Title:
WIND WHISTLE FROM FRONT EDGE
OF HOOD
Models:
'02 RAV4

SB629481

NV004-02

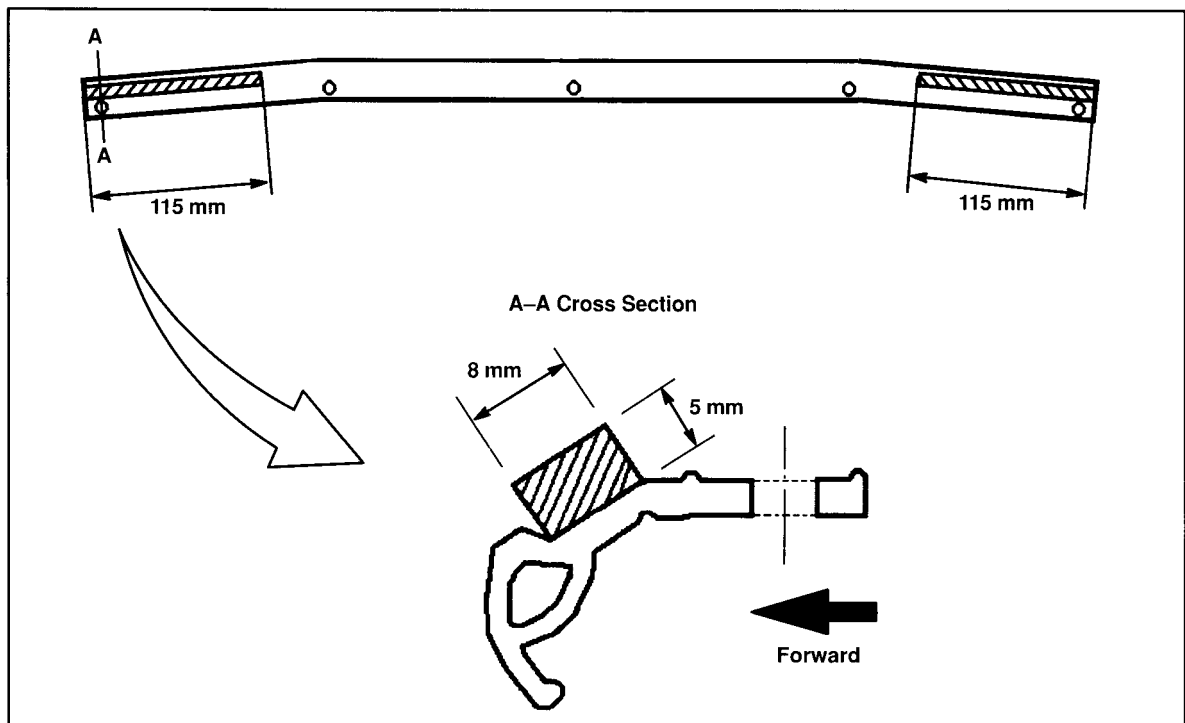
2. Cut two pieces of EPT sealer from the wind noise kit, and apply them to the hood seal as shown.

EPT Size**Length: 115 mm****Width: 8 mm****Thickness: 5 mm**
